Published by:  
Service Department Audio

# SERVICE NEWSLETTER

improved Power board ver. C

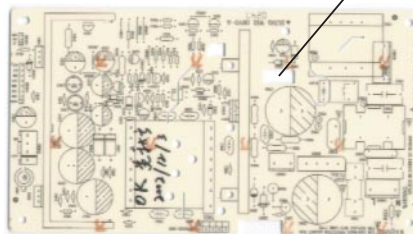
CURE : The phenomenon is caused by a thermal problem.  
Due to poor ventilation IC903 becomes too hot. Heat ventilation has been improved by adding hole(s) on Power board versions C and higher. For repairs replace the complete Power board with an improved one – codenumber 9665 000 18105.

hole(s) added  
(Transformer is  
removed for  
clearer view)

Figure 1

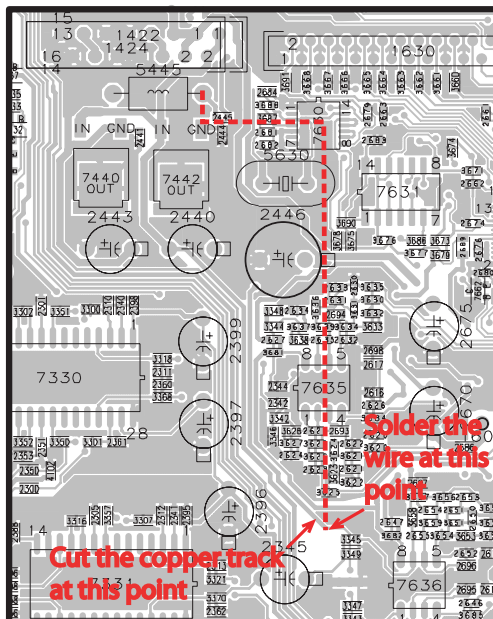
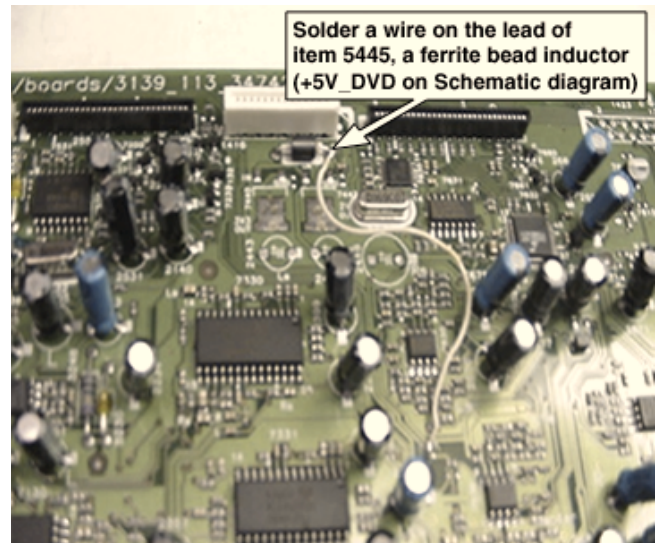
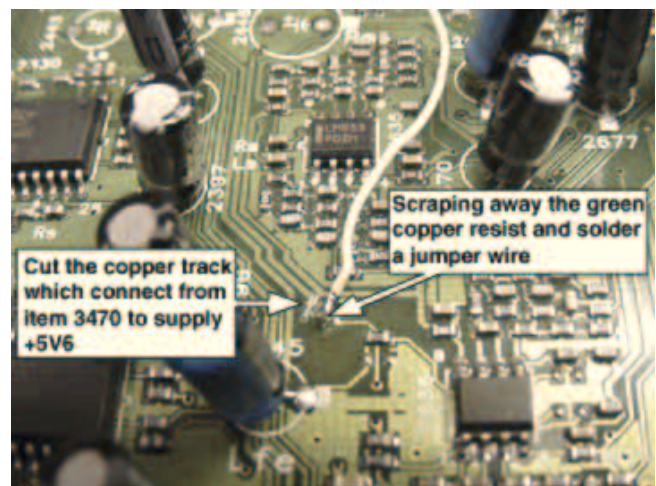
1. Cut the +5V6 supply to resistor 3470.
2. Connect a wire from resistor 3470 to coil 5445 (+5V\_DVD on Schematic diagram).
3. See figure 1..4 for details.
